BEAVERCREEK PLANNING COMMISSION
Regular Meeting – September 2, 2020, 6:00 p.m.

**CITY OF BEAVERCREEK
PLANNING COMMISSION
AGENDA ITEM REPORT**

| Meeting Date: 9-2-2020 | Reference Topic: PC 20-10 Land Use Plan Amendment, BCGolf Limited Partnership |

WHEREAS, James Connell, Agent for the Owner, 3650 Somerset Drive, Beavercreek, Ohio, 45431, has filed an application requesting approval of an ASRA Detailed Site Plan for the Resonant Sciences Addition to be located at 4085 Executive Drive; and

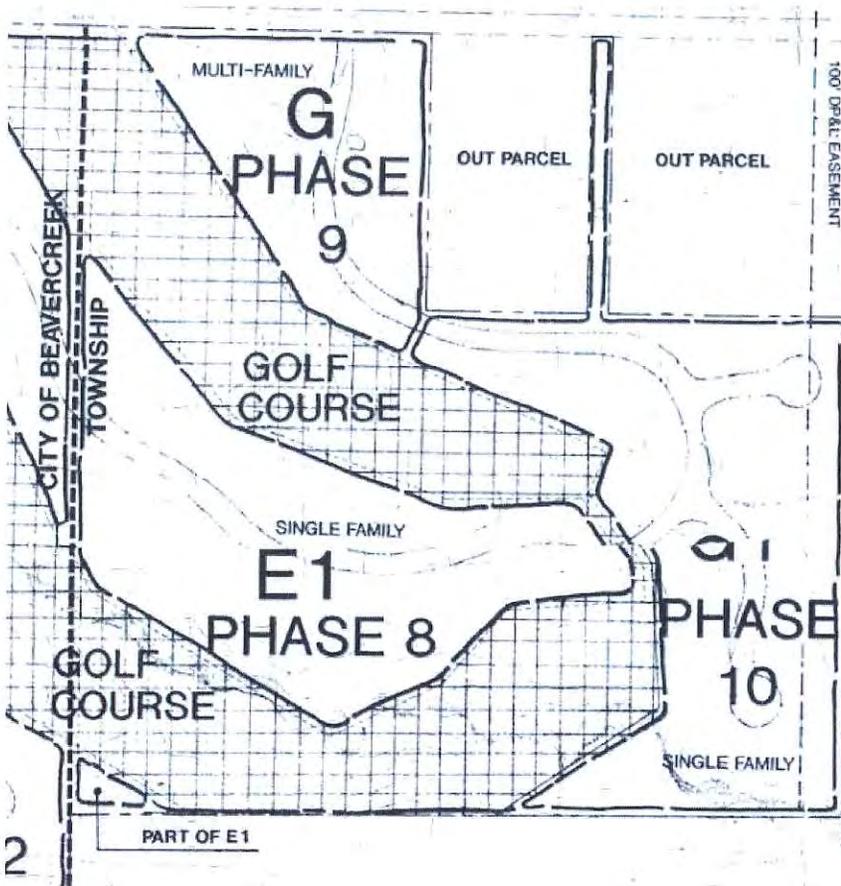
The property is located on the south side of New Germany – Trebein Road, east of the golf course, and is currently designated as Low-Density Residential (less than 3.01 dwelling units per acre). However, the current zoning of the property allows for a mixture of medium density residential on the northern 5.861 acres and low density residential on the southern 20.8 acres (“G and G1” on the original concept plan). Overall, this yields a density of 3.63 dwelling units per acre (du/ac) for the 26.7 acre area or a total of 97 units. The proposed Land Use Plan classification change would allow for up to 6 du/ac, or 160 units. In addition, the applicant owns 3 acres just east of the city limits, and is planning to annex this area into the City and propose it to be medium density as well. If included in the PUD, the 30 acre area, at medium density residential, would allow up to 180 units.

If this amendment were to be approved, before any construction could occur (other than what the current zoning allows), any potential applicant would need to rezone the property (which requires one Planning Commission and two City Council meetings) AND get a specific site plan approval (which requires one Planning Commission and one City Council meeting). Based on the language in the VPA (stating development should occur in similar scale and design to adjacent development), staff would only recommend approval of a PUD zoning amendment that concentrated higher density on the northern portion of the 30 acres which abuts New Germany Trebein Road and the multi-family across New Germany Trebein, and lower density on the southern portion (which is in closer proximity to the existing single family), so long as the overall density is not over 6 du/ac. Similarly, staff would only recommend approval of a specific site plan if adequate screening/buffering were able to be provided between the proposed development and the golf course/single family residential neighborhood. The concept plan that was provided by the requestor and sent to Planning Commission for consideration at the August 5th meeting does not meet these conditions, as it shows the units spread out uniformly rather than concentrated.

Staff is recommending approval of this requested Land Use Plan Amendment as highlighted in the attached Resolution.

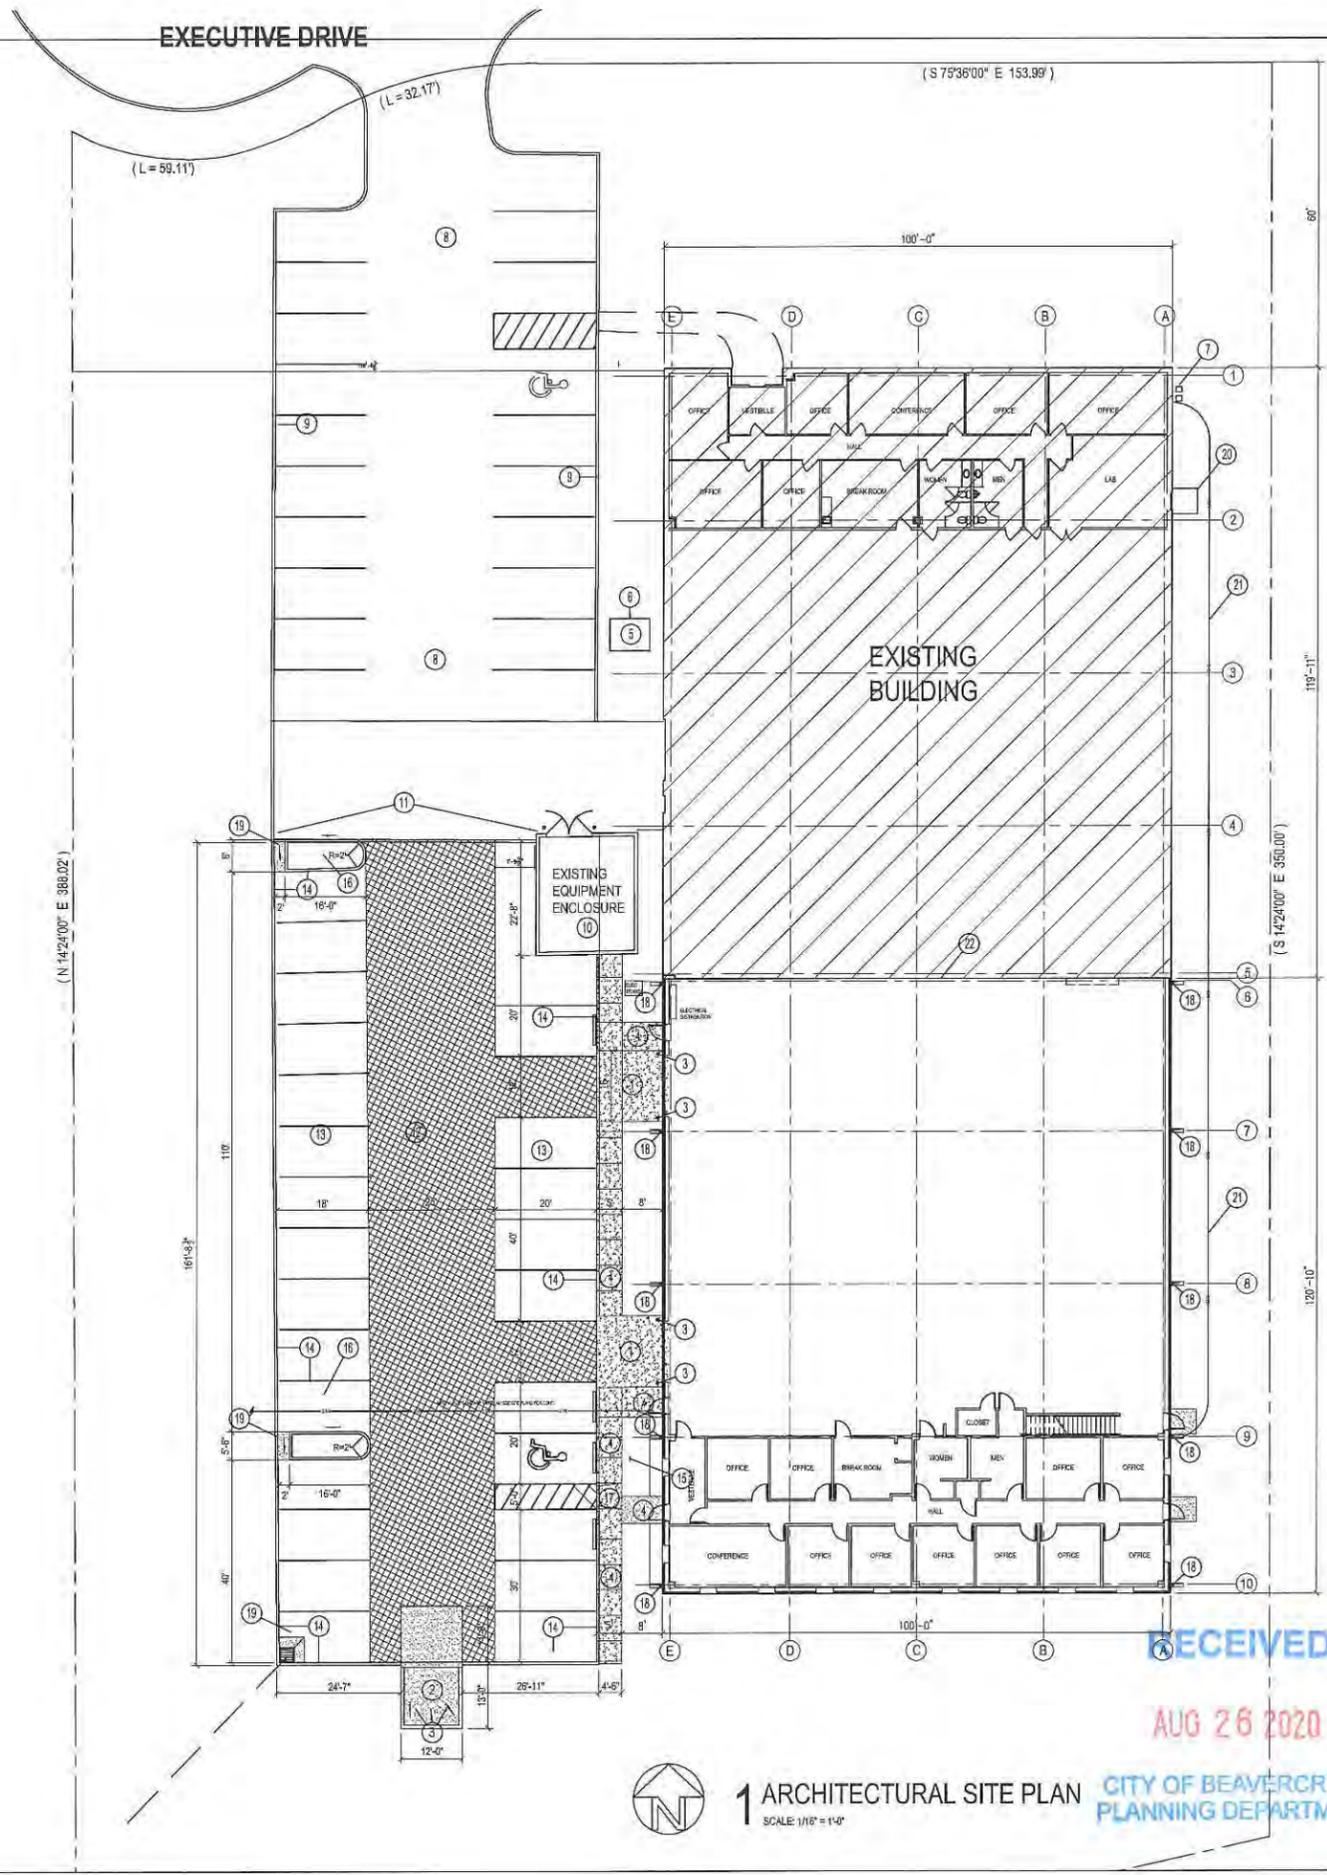
As shown in the attached plans, the proposed addition extends directly off the back of the existing building, maintaining all required setbacks.

As noted on the proposed site plan, the applicant is proposing to expand the existing parking lot in order to accommodate an additional 25 parking spaces. The zoning code does not specify a parking requirement for research labs with offices but the building will have 16 offices and a 25 employees total once the addition is completed. The provided 44 parking spaces are more than sufficient to accommodate this building expansion.

The applicant plans to install trees in the proposed landscape islands as well as trees along the rear of the new addition. Shrubs shall be located around the base of the building and a condition of approval will require that any mechanical equipment be screened with additional landscaping.

The applicant plans to continue the use of LED wall-pack lighting for the proposed addition. A condition of approval will require that the lights be full cut off fixtures to avoid light spill over into adjacent properties.

1. The approved plans for this development shall be the plans stamped "Received August 26, 2020", except as modified herein.
2. The approved building elevations shall be those plans stamped "Received August 5, 2020" except where modified herein.

3. A detailed landscape plan shall be reviewed and approved by the Planning Department prior to the execution of the required Development Agreement and the release of a zoning permit.

8. The façade shall not be painted or altered without the expressed approval of the Planning Department and/or Planning Commission.
9. Prior to the issuance of a zoning permit, final cut sheet details and photometric plans for lighting of the site shall be reviewed and approved by the Planning Department. All light fixtures shall be full cut off fixtures.
